Technical Service BULLETIN

EXCESSIVE SULFUR DIOXIDE ODOR

'03 – '04 4Runner (2UZ-FE)

ENGINE
EG020-04

ECM (PCM)
Identification
Chart

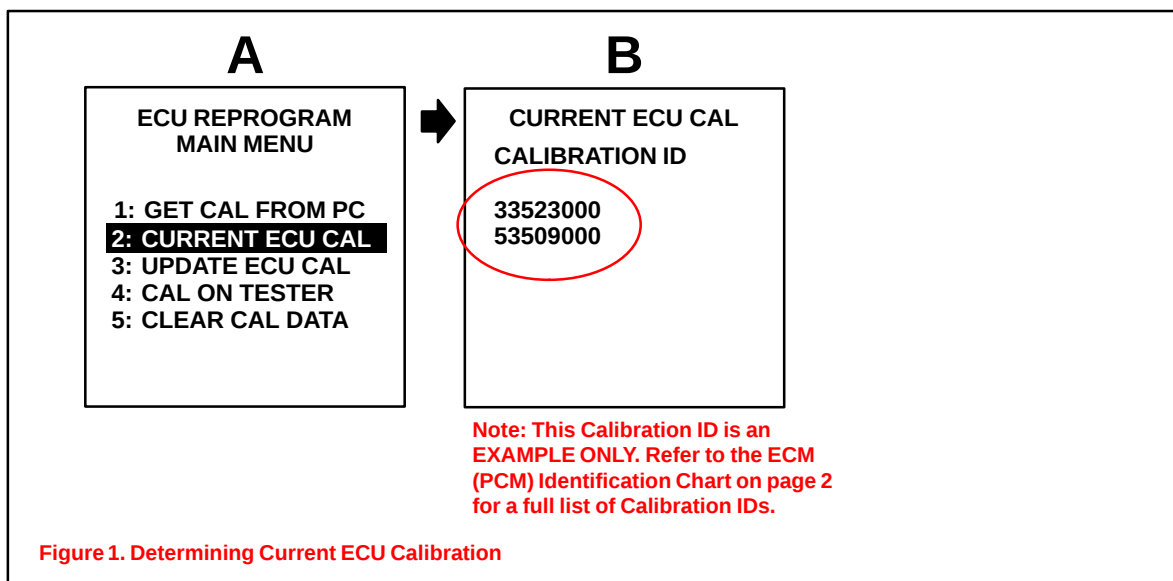
In order to reduce the sulfur dioxide odor, the Electronic Control Module (ECM) (SAE term: Powertrain Control Module/PCM) fuel cut control logic has been modified and a new catalyst is provided. Follow the repair procedure to reflash the ECM and replace the catalytic converter assembly.

MODEL YEAR	DRIVETRAIN	PREVIOUS CALIBRATION ID NUMBERS		NEW CALIBRATION ID NUMBER
2003 – 2004	2WD	Main	33523000 33514000 33514100 33514200	33523100
		Sub	53509000 53501000 53501100 53501200	53509100
2003	4WD	Main	33515000 33515100 33515200	33527100
		Sub	53502000 53502100 53502200	53511000
2004	4WD	Main	33527000	33527100
